Re: Turkey Point Unit 3
Docket Nos. 50-250
Response to NRC Request for Additional Information (RAI) Regarding
Extended Power Uprate (EPU) License Amendment Request (LAR) No. 205
and Unit 3 Mechanical/Civil Engineering Issues

RESPONSE TO NRC RAI REGARDING EPU LAR NO. 205
AND UNIT 3 EMCB MECHANICAL/CIVIL ISSUES

FIGURE 1

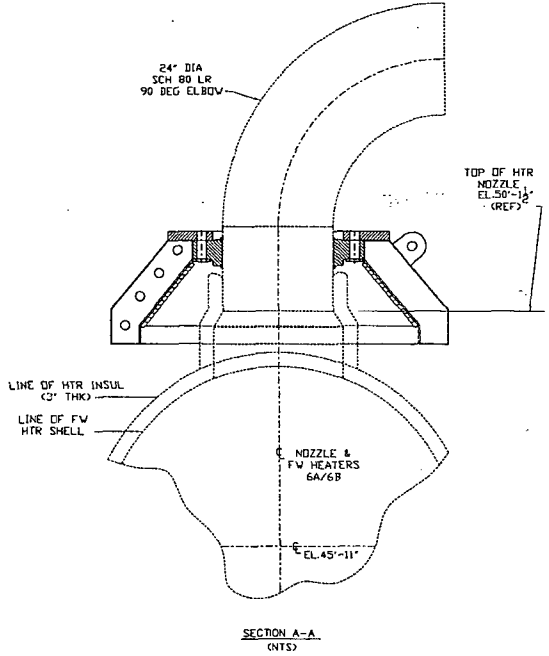
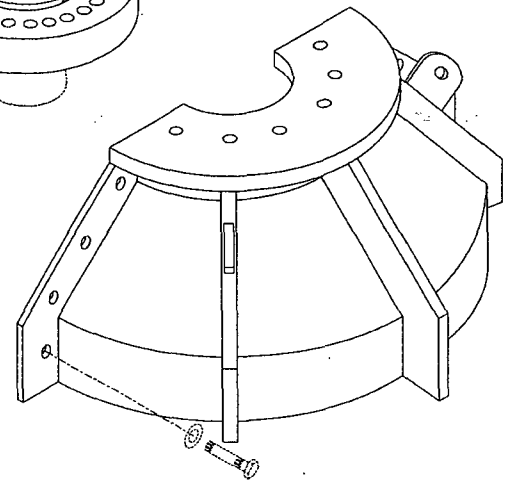
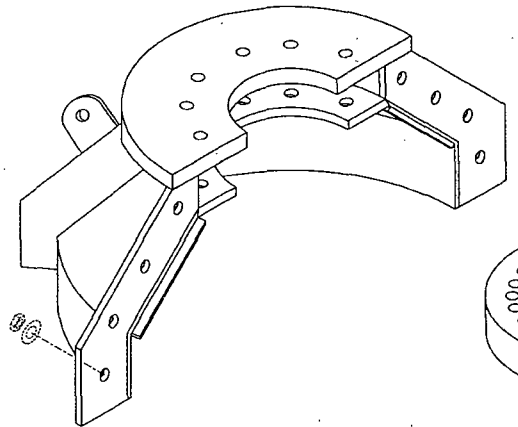
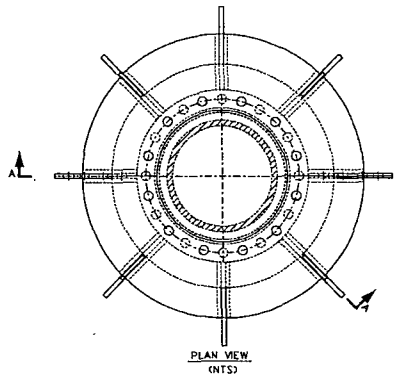
- 3. In Section 2.5.1.3.2.3.4 (Attachment 4, Licensing Report) the licensee notes the replacement of the 6th feedwater heaters will result in resizing of the discharge piping from 18 inches to 24 inches. The jet impingement zones of influence are increasing due to EPU requiring modifications to shield equipment important to safety. These statements indicate that the evaluations (design and analysis) of 24 inch discharge piping, and shield equipment required to support the EPU have not been performed yet. Therefore, the licensee has not provided sufficient technical information for staff's review to determine whether reasonable assurance exists to conclude that the integrity of the required modifications are structurally adequate for the proposed EPU.**

Two of the terminal end break locations for the main feedwater (FW) piping are at the outlet of the PTN Unit 3 E6A/B FW Heaters. Due to increase of the FW Heater outlet nozzle diameter to 24 inches from the current outlet nozzle diameter of 18 inches, there is an associated increase in the size of the pipe break zone of influence. The calculated zone of influence for EPU conditions is 18 ft. for the postulated break (increased from 13.5 ft.). The impact to components important to safety from the increased jet impingement zone of influence has been evaluated in the PTN design change process for the replacement of the number 6 FW Heater in PTN Unit 3. Walkdowns encompassing a 18 foot zone of influence around the number 6 FW Heater outlet pipe have been performed to identify equipment important to safety. Safety-related pressure transmitters PT-3-486, PT-3-464, and PT-3-476 were identified to fall within the zone of influence of a circumferential FW pipe rupture at the outlet nozzle terminal ends in Unit 3. These components are located within the main steam valve platform trestle area.

To protect these components, new deflector shields will be installed on the FW outlet piping at the postulated circumferential break locations at each of the number 6 FW Heaters outlet nozzles. The shields are designed to redirect jet forces and guide streams in a direction away from the safety-related equipment. The design of the HELB deflector shield is shown in Figure 1.

The design and analytical details for the HELB deflector shield for PTN Unit 3 were completed, and will be incorporated into the FW system modification package. The deflector shields are designed as Class III Structures, Systems, and Equipment, but using the same design allowable stresses as those used for Class I Structures, Systems, and Equipment defined in Appendix 5A of the PTN Updated Final Safety Analysis Report (UFSAR) since the criteria for Class III includes criteria (allowables) for faulted conditions.

Principal stresses were calculated using standard structural finite element method techniques, under various scenarios of applied loading, from the postulated terminal end break. The maximum principal stresses were determined to be less than the stress limits defined in Appendix 5A of the PTN UFSAR for hypothetical accident conditions. As such, no loss of function is assured.
